Wollongong Local Planning Panel Assessment Report | 1 June 2021

WLPP No.	Item No. 3
DA No.	DA-2020/614
Proposal	Residential - demolition of existing dwellings and outbuildings and the construction of a five (5) storey residential flat building with basement parking
Property	16 Market Place Wollongong - Lot 4 DP 997089 18 Market Place Wollongong – Lot 1 DP 153262
Applicant	Borst & Co Architecture Pty Ltd
Responsible Team	Development Assessment and Certification - City Centre Major Development Team (AS)
Development cost	\$5,174,817.00
Lodgement date	24 June 2020
Prior WLPP meeting	None

Assessment Report and Recommendation

○ Long Section AA
 Scale 1 : 200

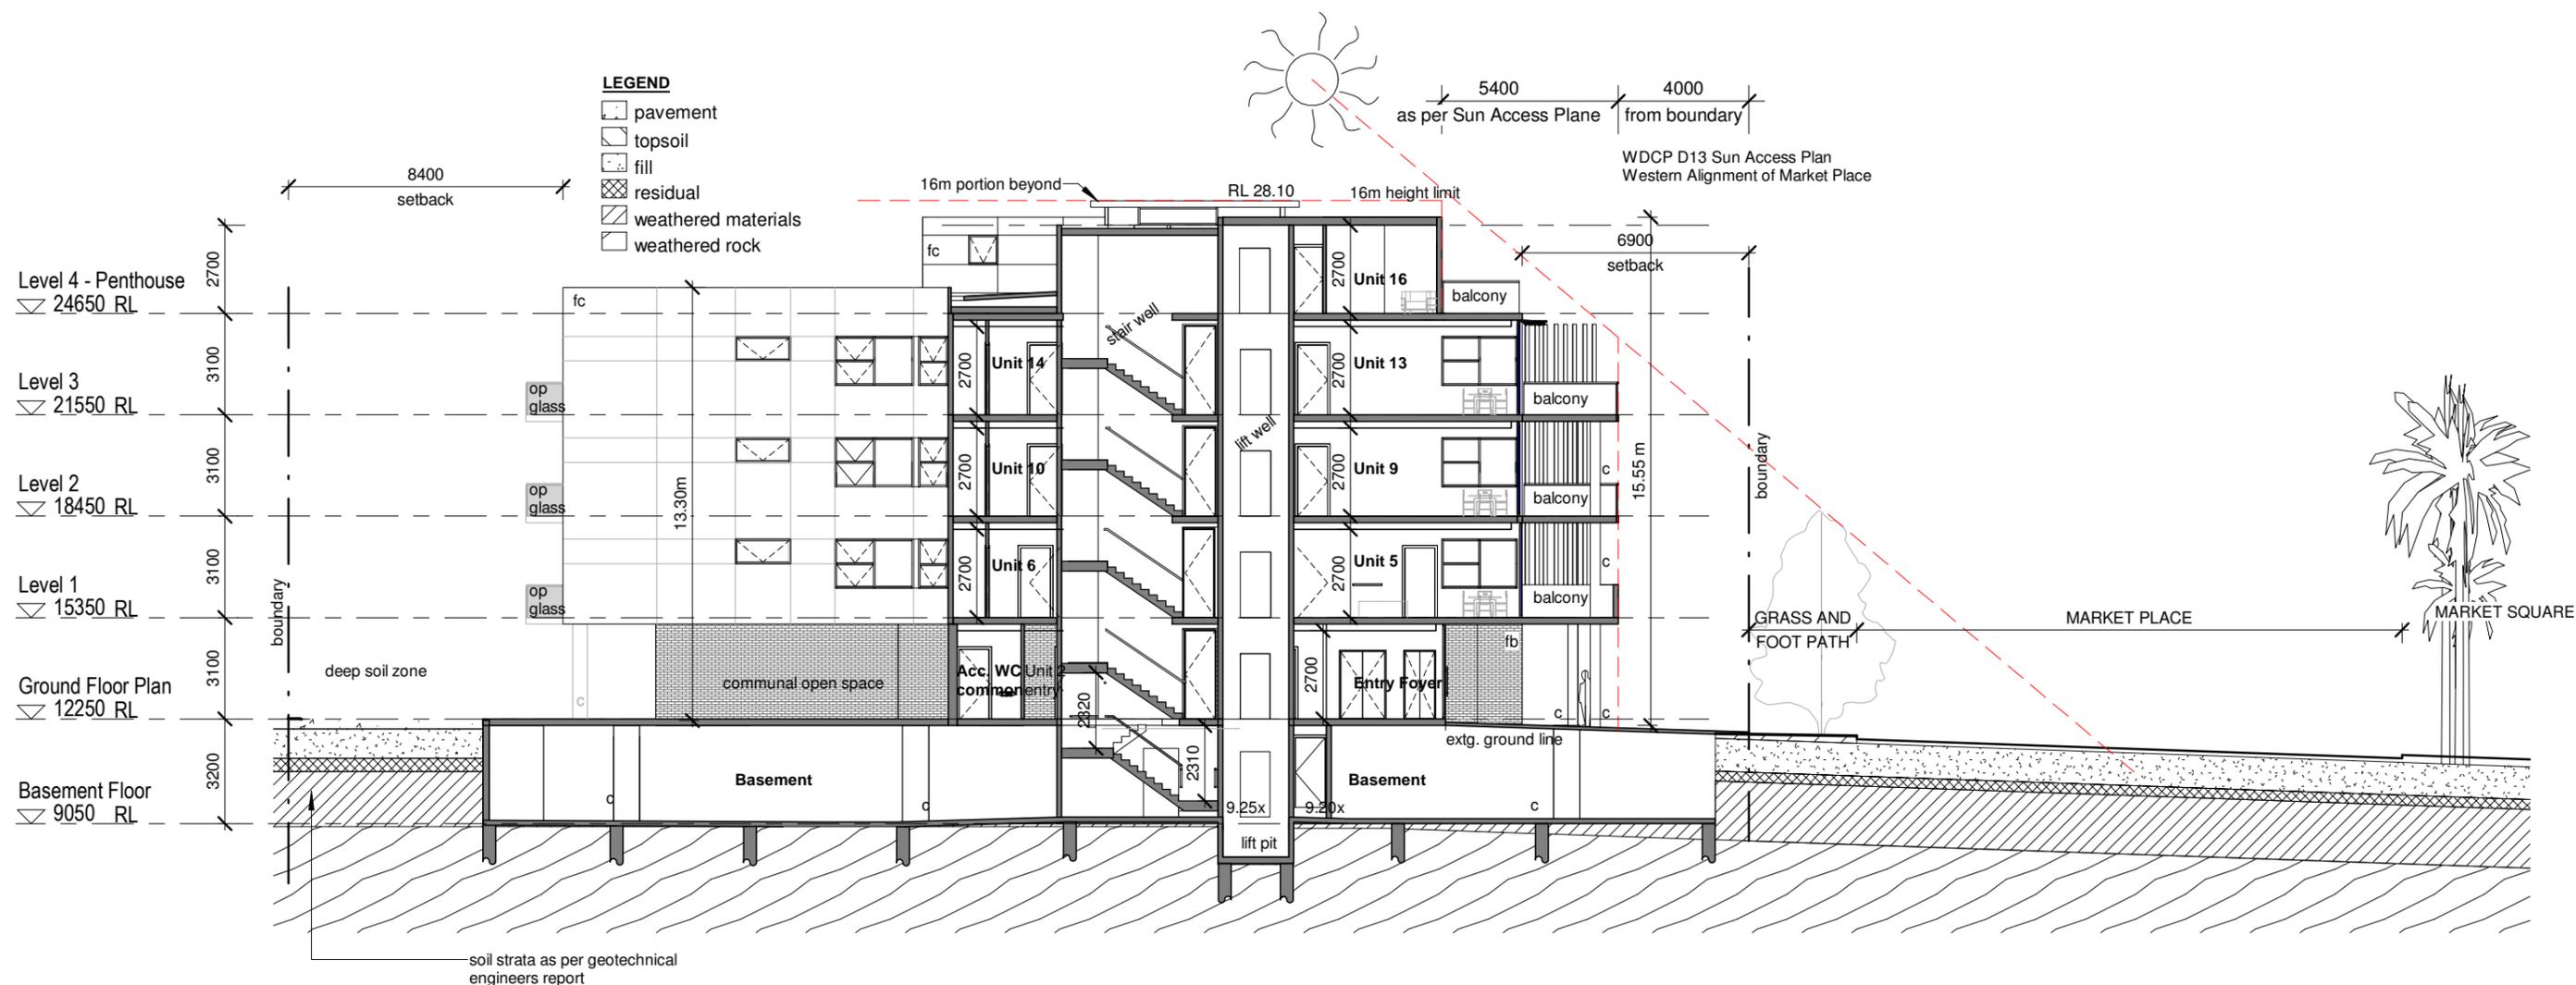
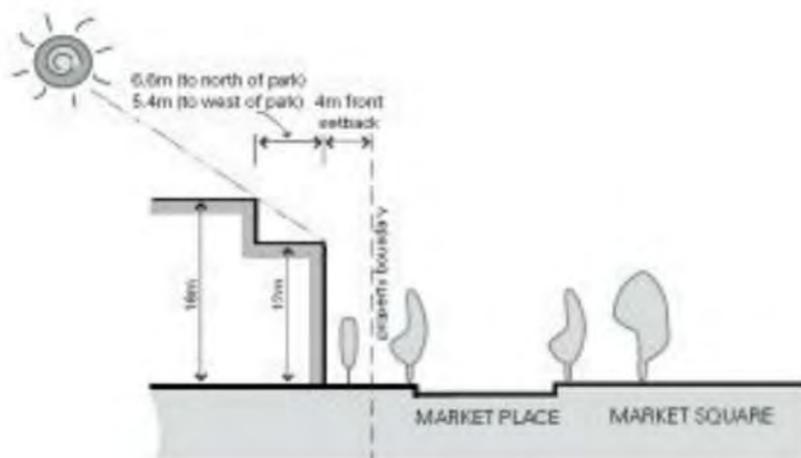
The proponent has included the Figure 22.1 diagram on drawing DA16. However, it appears that when applied to the proposed development (in the section) the sun access plane has been drawn incorrectly using a 40dg angle to generate the plane at the 12m setback point.

These errors mean that the proposed section cannot be assessed confidently. At this stage it appears that the proposed street-wall will penetrate the sun access plane. The shadow diagram for 21st June 2pm (Drawing DA36) appears to confirm this.

The proponent is required to provide a dimensioned sectional drawing showing the accurate sun access plane as illustrated in DCP D13 Figure 22.1 and explained above. The 12 and 16m height limits are to be taken from ground level. Overshadowing diagrams are to be updated to illustrate the overshadowing created by the proposed development in a colour or shade that allows it to be discerned as distinct from the existing overshadowing from adjacent buildings.
